COUNCIL ASSESSMENT REPORT

WESTERN REGIONAL PLANNING PANEL

PANEL REFERENCE & DA NUMBER	PPSWES-129 – RVA0002/2022		
PROPOSAL	Electricity Generating Works (2 x 5MW Solar Farms) and Associated Infrastructure		
ADDRESS	3B Sydney Road, Burrundulla (Lot 6 DP1069441)		
APPLICANT/OWNER	Applicant: Timothy Allen - Beatty Hughes & Associates C/- IT Power Australia Pty Ltd Owner: Burrundulla Pty Ltd		
DATE OF LODGEMENT	8 February 2022		
REGIONALLY SIGNIFICANT CRITERIA	Development Application subject of Review. Original application referred to Western Regional Planning Panel in accordance with the requirements of Schedule 4A of the Environmental Planning and Assessment Act 1979 and Clause 22 of the State Environmental Planning Policy (State and Regional Development) 2011, as the application is defined as 'private infrastructure' with a capital investment value exceeding \$5,000,000.		
LIST OF ALL RELEVANT S4.15(1)(A) MATTERS	 \$13,200,000 for all works. State Environmental Planning Policy (Biodiversity and Conservation) 2021 State Environmental Planning Policy (Resilience and Hazards) 2021 State Environmental Planning Policy (Transport and Infrastructure) 2021 State Environmental Planning Poli

Figure 5: Revised site layout with landscaping detail - July 2022

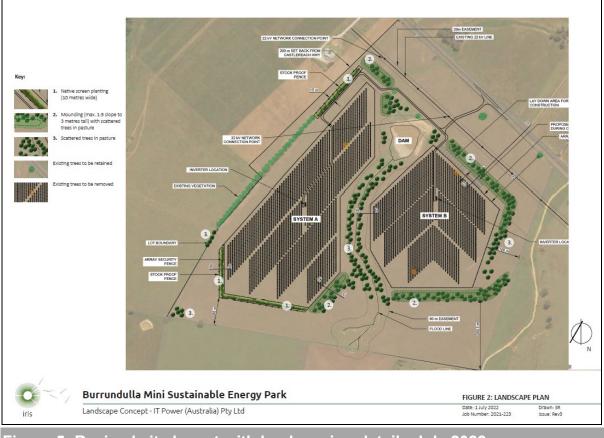
The modifications to the landscape plan recently submitted in order to address the visual impacts of the proposal is considered to further exacerbate the concerns previously raised regarding the impacts of the development on the rural locality and the suitability of the site for the development.

The modified development does not address the key issue of visual impacts on the locality and the inclusion of 3m high, elongated earth mounds in order to 'screen' the development from the Highway and to the south-eastern landowners does not consider the amount of fill required for this to be successful nor the impacts the placement of such a significant amount of fill will have on the future use of the land.

Whilst the Applicant has submitted amended plans to provide a greater development setback from the Castlereagh Highway (200m) along with the earth mounds with landscaping and the parking / laydown area now located behind the mounds, the applicant has still failed to consider the significant visual intrusion and change in landscape character as a result of the proposed development.

The Visual Impact Assessment has not been updated to reflect the modifications to the landscape plans revised in July 2022 and has also not considered sensitive receptors (dwellings) from surrounding land located at higher elevations.
